Monticello Nuclear Generating Plant

License Amendment Request dated June 22, 1995

Proposed Changes Marked Up on Existing  
Technical Specification Pages

~~Figure 3.5-1 Single Loop Operation Surveillance Power/Flow Curve~~

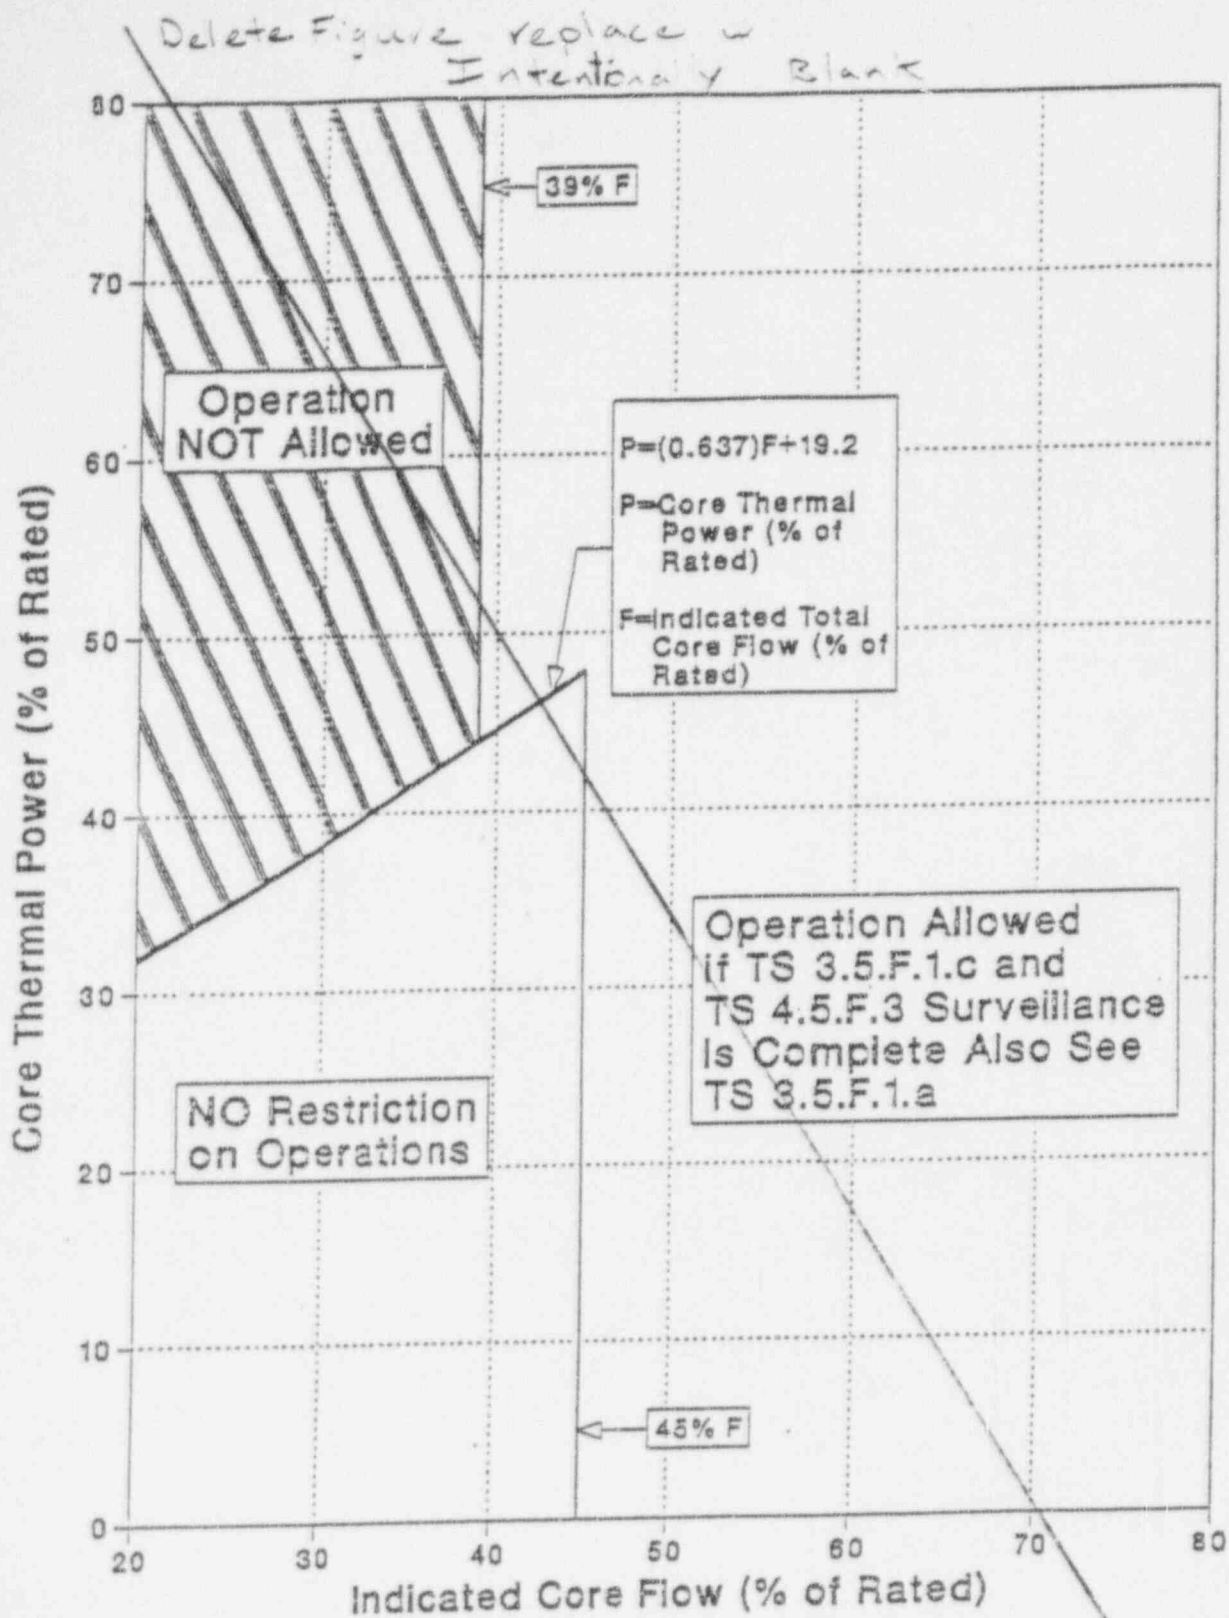
b. ~~Total core flow will be maintained greater than 39% when core thermal power is above the limit specified in Figure 3.5.1.~~  
Technical specification 3.5.F.1 and 3.5.F.2 are met.

~~2. The following baseline noise levels will be obtained prior to operation with only one recirculation pump in operation at a core thermal power greater than that specified in Figure 3.5.1 or with a core flow greater than 45% provided that baseline values have not been established since the last core refueling. Baseline values will be taken with only one recirculation pump running.~~

~~3. With only one recirculation loop in operation at a core thermal power greater than that specified in Figure 3.5.1 or with a core flow greater than 45%, determine the following noise levels at least once per 8 hour period and within 30 minutes after a core thermal power increase of greater than 5% of rated thermal power.~~

~~b. reduce core thermal power to less than the limit specified in Figure 3.5.1.~~

Insert  
new  
text  
found  
on  
next  
page ~~Specification 3.5.F.1 is based upon providing assurance that neutron flux limit cycle oscillations, which have a small probability of occurring in the high power/low flow corner of the operating domain, are detected and suppressed. Under certain high power/low flow conditions that could occur during a recirculation pump trip and subsequent Single Loop Operation (SLO) where reverse flow occurs in inactive jet pumps, a hydraulic/reactor kinetic feedback mechanism can be enhanced such that sustained limit cycle oscillations of flow noise with peak to peak levels several times normal values are exhibited. Although large margins to safety limits are maintained when these limit cycle oscillations occur, they are to be monitored for, and suppressed when flux noise exceeds the three time baseline value by inserting rods and/or increasing coolant flow. The line in Figure 3.5.1 is based on the 80% rod line below which the probability of limit cycle oscillations occurring is negligible.~~

~~APRM and/or LPRM oscillations in excess of those specified in Specification 3.5.F.1.e could be an indication that a condition of thermal hydraulic instability exists and that appropriate remedial action should be taken. By restricting core flow to greater than or equal to 39% of rated, which corresponds to the core flow at the 80% rod line with 2 recirculation pumps running at minimum speed, the region of the power/flow map where these oscillations are most likely to occur is avoided (Ref. 1).~~

1. Intentional entry into the stability exclusion region of the power-flow map defined in the Core Operating Limits Report (COLR) is prohibited. If entry into the stability exclusion region does occur, immediately perform one or more of the following until the stability exclusion region has been exited:
  - a. Insert control rods,
  - b. Increase the speed of an operating recirculation pump.
2. Entry into the stability buffer region of the power-flow map as defined in the COLR is prohibited unless the power distribution controls as defined in the COLR are in effect. If the power distribution controls are not in effect and entry into the stability buffer region does occur, immediately perform one or more of the following until the stability buffer region has been exited:
  - a. Insert control rods,
  - b. Increase the speed of an operating recirculation pump.

The reactor is designed such that thermal hydraulic oscillations are prevented or can be readily detected and suppressed without exceeding specified fuel design limits. To minimize the likelihood of a thermal-hydraulic instability, a power-flow exclusion region, to be avoided during normal operation, is calculated using the approved methodology as stated in specification 6.7.A.7. Since the exclusion region may change each fuel cycle the limits are contained in the Core Operating Limits Report. Specific directions are provided to avoid operation in this region and to immediately exit upon an entry. Entries into the exclusion region are not part of normal operation. An entry may occur as the result of an abnormal event such as a single recirculation pump trip. In these events, operation in the exclusion region may be needed to prevent equipment damage, but actual time spent inside the exclusion region is minimized. Though operator action can prevent the occurrence and protect the reactor from an instability, the APRM flow biased scram function will suppress oscillations prior to exceeding the fuel safety limit.

Power distribution controls are established to ensure the reactor is operated within the bounds of the stability analysis. With these controls in place, there is confidence that an oscillation will not occur outside of the stability exclusion region. Without these controls, it is theoretically possible to operate the reactor in such a manner as to cause an oscillation outside of the exclusion region. A nominal 5% power-flow buffer region outside of the exclusion region is provided to establish a stability margin to the analytically defined exclusion region. The buffer region may be entered only when the power distribution controls are in place.
